500 FAIRVIEW

MARCH 19, 2013

**PUDA REVISION
SUBMITTAL
03.19.2010**

**02.12.2013
PRE-SUBMITTAL
CONFERENCE
MEETING**

WEST ELEVATION IMPROVEMENTS

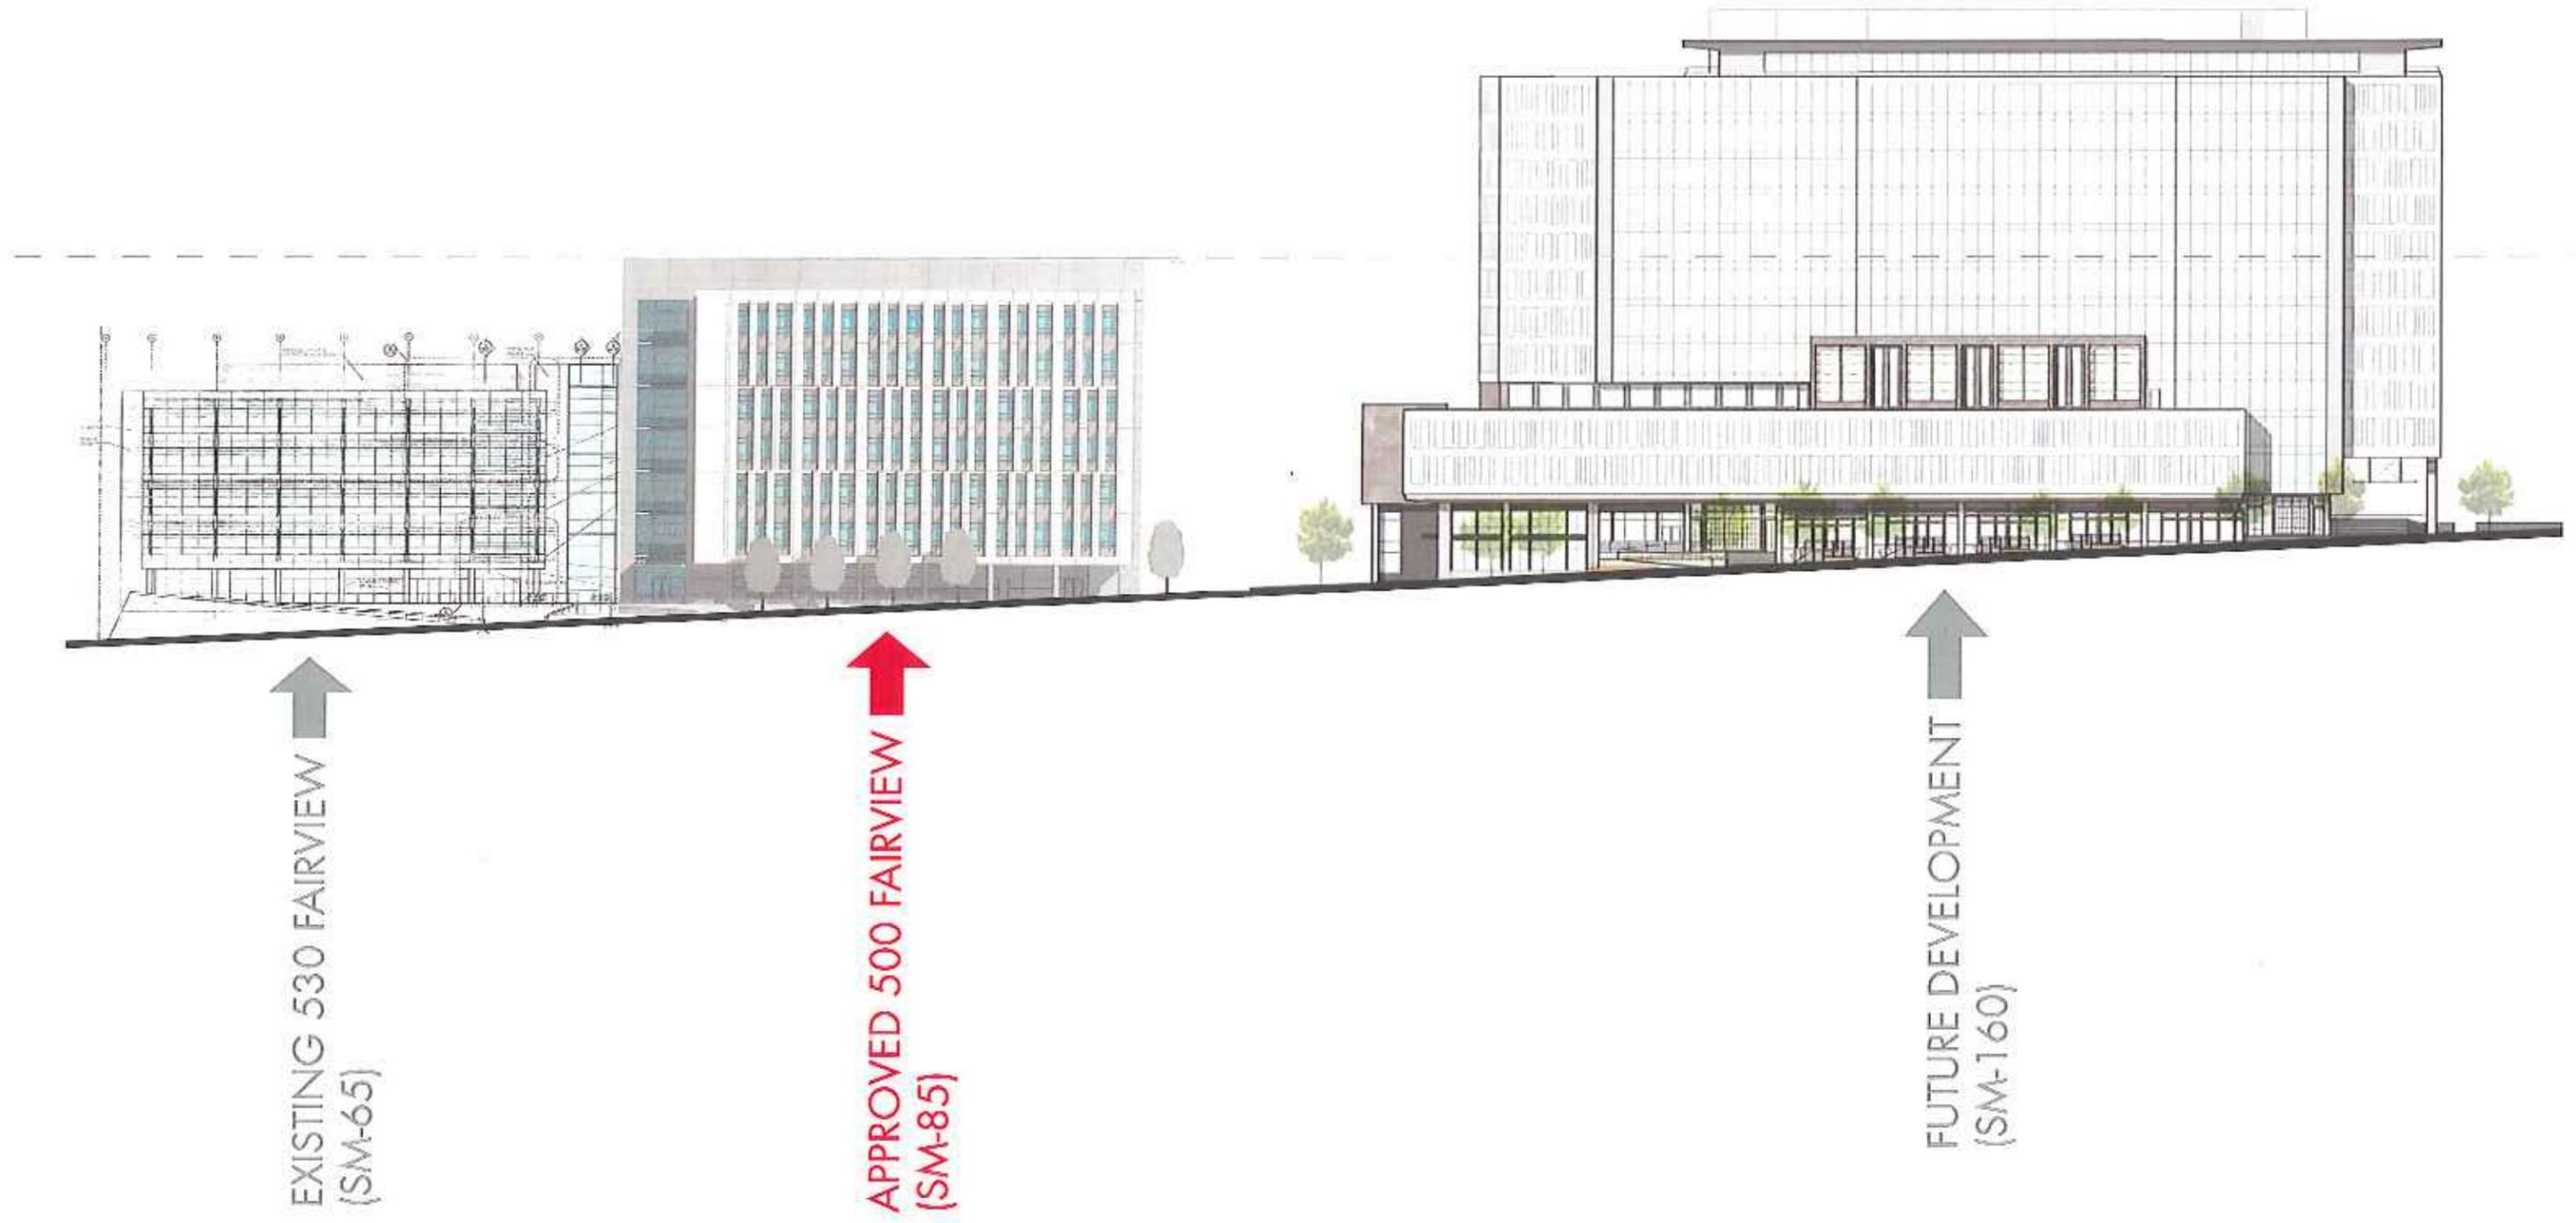
B-1 HEIGHT, BULK & SCALE COMPATIBILITY
The proposed building maintains the massing permitted for SM-85 while responding to the scale of neighboring planned developments (SM-160) by simplifying building elements.

PROPOSED MASSING IMPROVEMENTS

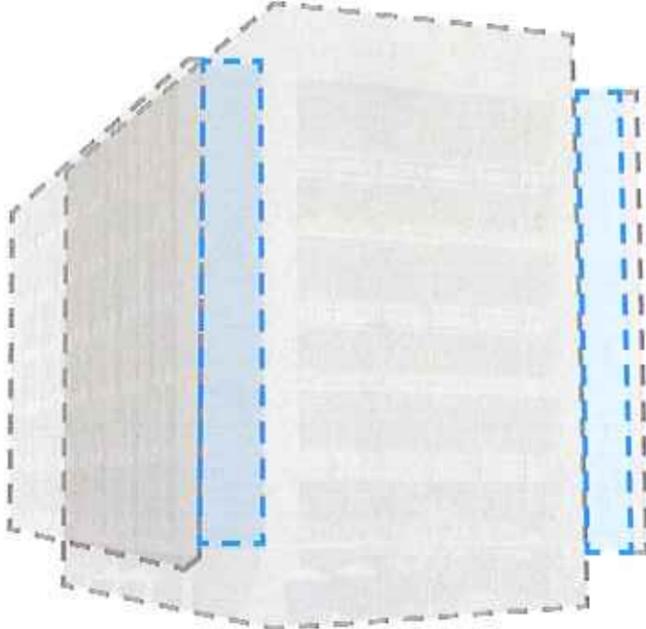
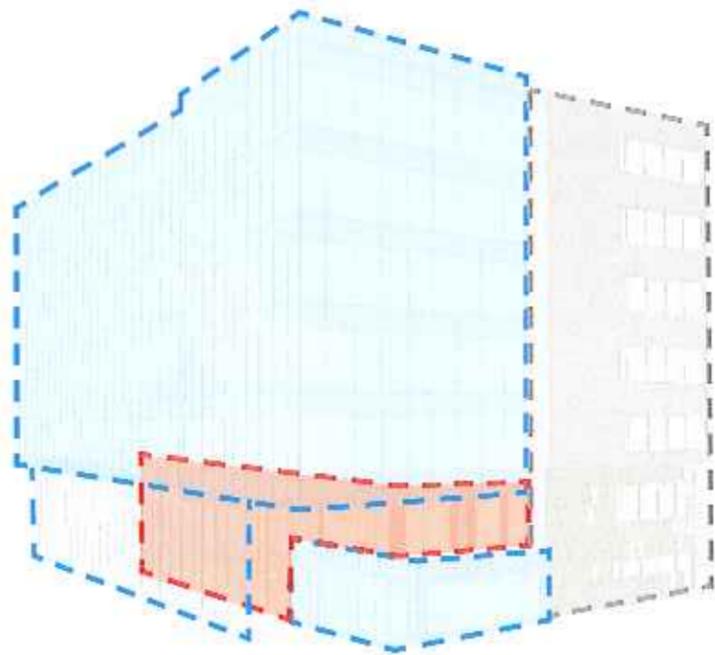
C-2 ARCHITECTURAL CONCEPT & CONSISTENCY
The proposed building improves upon the approved design's urban response with a more transparent facade.

C-3 HUMAN SCALE
Fenestrations and screening elements in both the horizontal and vertical direction improve upon the approved design's intent to relate to the human-scale.

SOUTHEAST CORNER IMPROVEMENTS

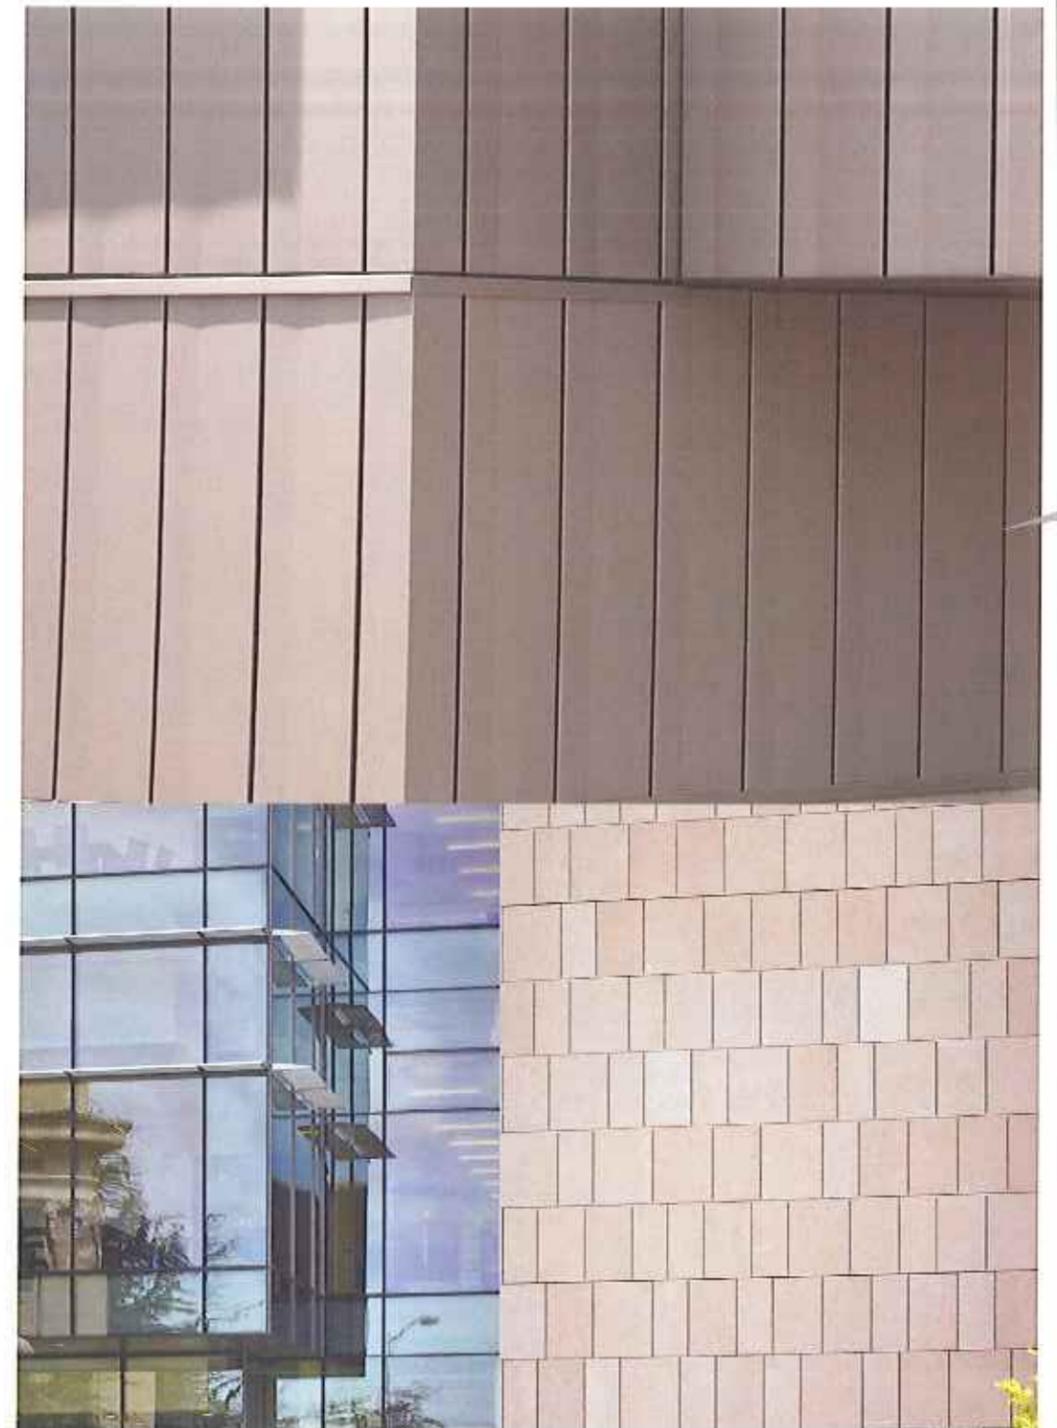
D-2 BLANK WALLS
The proposed design improves the South facade along Republican with increased transparency and rich landscaping

A-5 RESPECT FOR ADJACENT SITES
The proposed design maintains the desire for privacy for residents of Pete Gross House by strategically locating opacity in the East facade.

E-2 LANDSCAPING TO ENHANCE THE BUILDING & SITE
The proposed design provides rich landscaping at the ground level with additional landscape screening for residentially-scaled neighboring buildings.

C-4 EXTERIOR MATERIALS
The proposed building improves upon the approved design by maximizing vision glass, and replacing opaque materials with spandrel glass and light metal panel.
